#### PLAN COMMISSION Minutes

June 13, 2022 4:30 p.m.

## 5. Initial review and set public hearing date: Repeal & recreate Section § 550-106, Visibility Standards

Figure 550-106 Visibility Standards

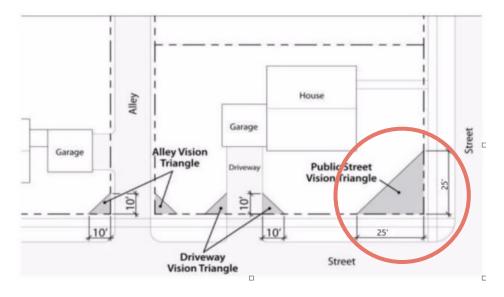
#### See red circle in schematic on page 5

There was great concern expressed by commission members on the applicability of the proposed vision triangle with the twenty five (25) foot dimension anchored at the property pin as it applies to typical residential property lots in Watertown.

After continued discussion, Administrator Maas recommended that the proposed document be returned to engineering for further review and further action. This recommendation was well received.
